RF	DRAWN BY		OSPACE LTD ONTARIO, CANADA	
1	CHECKED	APPROVED	DRAWING NO. DSI 9302	SHEET	REV. A
Ī	DATE	-1	TITLE		SCALE
1	05.05.16		STRUT MODIFICATION	KIT	NTS
	A	05.05.16	NEW ISSUE

DART SERVICE INSTRUCTION

TO AMEND INSTALLATION INSTRUCTIONS IIN-D205-633 REV. A

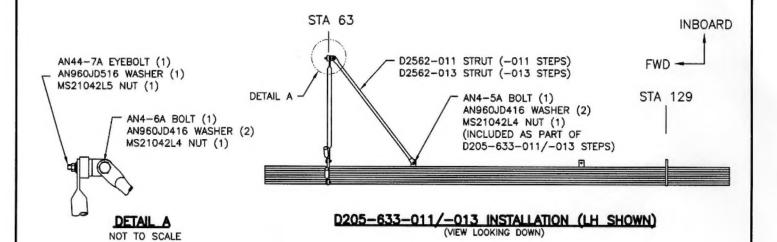
TO MAKE DART D205-633-011/-013 STEPS AT CHG001 COMPATIBLE WITH EQUIPMENT THAT INTERFERES WITH THE INSTALLATION OF THE D2562-001 STRUT (-011 STEPS) OR THE D2562-003 STRUT (-013 STEPS) AT STA 129, IT IS ACCEPTABLE TO INSTALL THE D2562-011 STRUT (-011 STEPS) OR D2562-013 STRUT (-013 STEPS) INSTEAD AS SHOWN BELOW:

FOR D205-633-013 CHG 002 OR LATER, REMOVE (1) D2562-003 STRUT, (1) AN5-6A BOLT, (1) AN4-5A BOLT AND (1) AN960JD516 WASHER AND ADD (1) D2562-013 STRUT, (1) AN44-7A EYEBOLT AND (1) AN4-6A BOLT, SO THAT THE STEP CAN BE INSTALLED AS SHOWN ABOVE.
